# **FREDERICK COUNTY PLANNING COMMISSION**

**October 10, 2018**

**TITLE:** **Dynamic Automotive (Old National Pike)**  
**FILE NUMBER:** **SP-18-04, AP# 18534, AFPO# 18365, FRO# 18535; SWM# 18584**

**REQUEST:** **Site Development Plan Approval**  
The Applicant is requesting Site Development Plan approval for a 5,400 s.f. Automotive Repair and Service Shop located on a 1.54-acre Site.

Figure 2- View to east toward intersection of Old National Pike and Mussetter Road

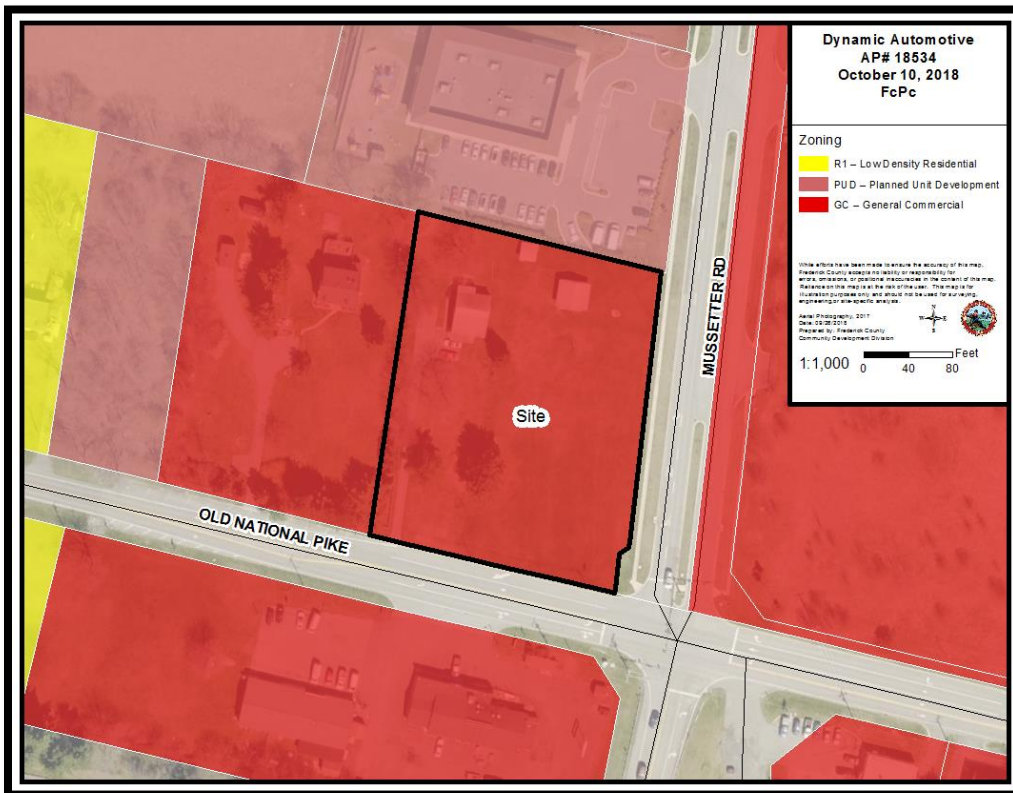
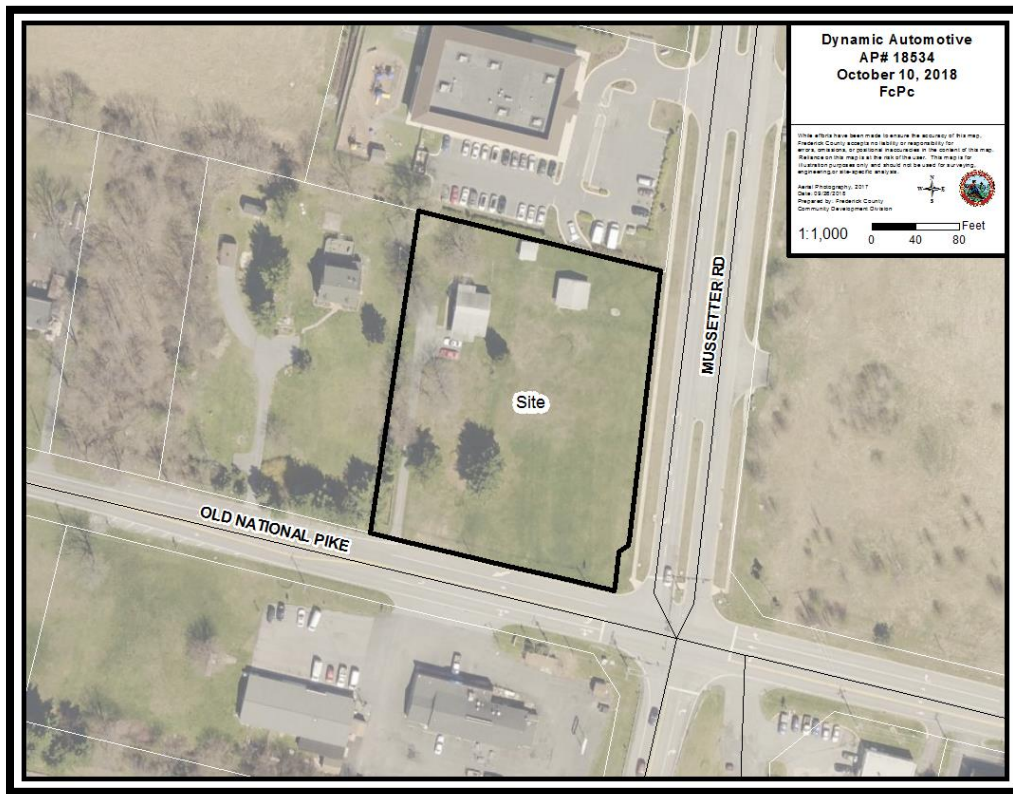
I-70 is located approximately 275 feet south of the proposed automotive repair shop.
